FINAL REVISED REMEDIAL PROJECT MANAGERS MEETING NOTES AND SUMMARY 20
JULY 2011 WITH TRANSMITTAL NS NEWPORT RI
10/28/2011
TETRA TECH NUS

Subject: Final REVISED RPM Meeting Notes and Summary July 20, 2011
NAVSTA Newport, Newport Rhode Island

Meeting Notes
Remedial Project Manager Meeting, 7/20/11
NAVSTA Newport, Rhode Island

Figure 2 . Sampling locations for Sedflume core collection. Red diamonds indicate locations originally designated for core collection where coring was unsuccessful. Blue diamonds indicate loations were cores were successfully retrieved.

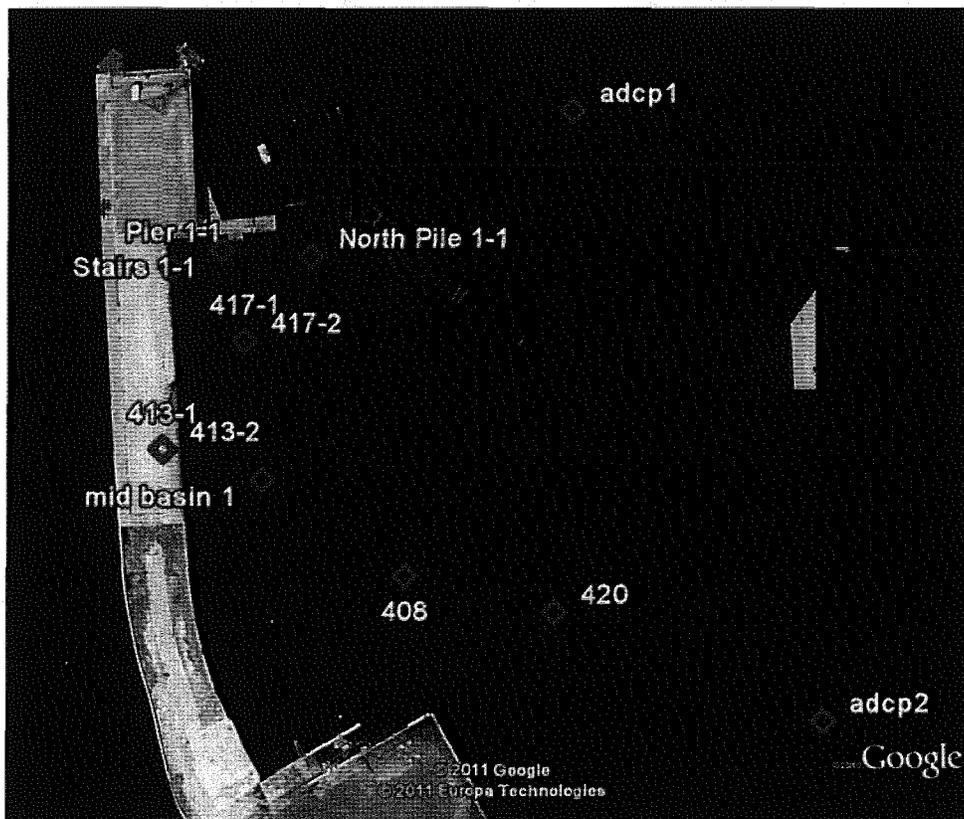
S. Parker stated that the sedflume testing could not be done in some areas because the core barrel could not penetrate the sediment substrate (see Figure 2 in Attachment 3). K. Keckler stated that the ERDC Vicksburg team has agreed to attempt to collect samples using different equipment during the field season for the Derecktor Shipyard work. S. Parker noted that if new data is collected for Gould Island, it will be too late to use in the FS report: The sediment transport model is expected to be drafted next month and that information will go into the Draft FS in September. The Navy does not want to rewrite the transport model or wait to write the draft FS. In addition, the information from the model is not expected to change which remedies are developed in the FS.
